Access Compliance Report

Public Rights-of-Way

Intersection ID: 52288	Main Street: STEELE_CREEK_RD	Cross Street: DIXIE_RIVER_RD	Location: N
ADA ID: EA5CAACA563C	Ramp Type: Para	Initial Pass/Fail: Fail	Overall Compliance: No
			Severity Score: 13.75

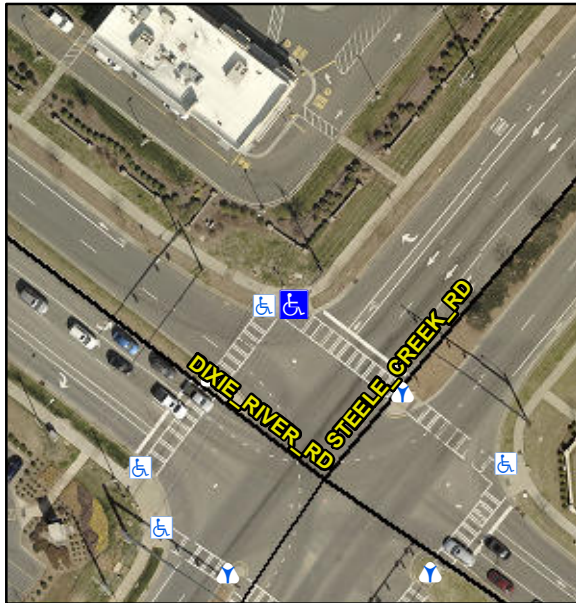
LT RP < 5%

R304.3.2, R304.5.3

Compliance	Description	Data	Compliance	Description	Data
N/A	Ramp Length LT (in)	57.0	N/A	Ramp Length RT (in)	58.0
Yes	Ramp Width LT (in)	83.0	Yes	Ramp Width RT (in)	76.5
Yes	Ramp Slope LT (%)	4.4	No	Ramp Slope RT (%)	9.5
Yes	Ramp XSlope LT (%)	1.8	No	Ramp XSlope RT (%)	4.6
N/A	Landing Length (in)	N/A	N/A	DWS Provided?	N/A
N/A	Landing Width (in)	N/A	N/A	DWS Contrast?	N/A
N/A	Landing Slope (%)	N/A	N/A	DWS Length (in)	N/A
N/A	Landing X Slope (%)	N/A	N/A	DWS Full Width?	N/A
N/A	Landing Curb? (Y/N)	N/A	N/A	DWS Offset (in)	N/A
N/A	Shared Landing?	N/A			
N/A	Gutter Ponding?	N/A	N/A	Gutter Slope (%)	N/A
N/A	Gutter Lip Ht (in)	N/A	N/A	Gutter X Slope (%)	N/A
N/A	Painted X Walk1?	Yes	N/A	Painted X Walk2?	N/A
	X Walk 1 Direction	To SE		X Walk 2 Direction	N/A
N/A	X Walk 1 Width (in)	118.0	N/A	X Walk 2 Width (in)	N/A
	X Walk 1 Slope (%)	1.4		X Walk 2 Slope (%)	N/A
	X Walk 1 X Slope (%)	1.3		X Walk 2 X Slope (%)	N/A
N/A	Ramp inside XWalk1?	Yes	N/A	Ramp inside XWalk2?	N/A

Remove & Replace Entire Ramp.
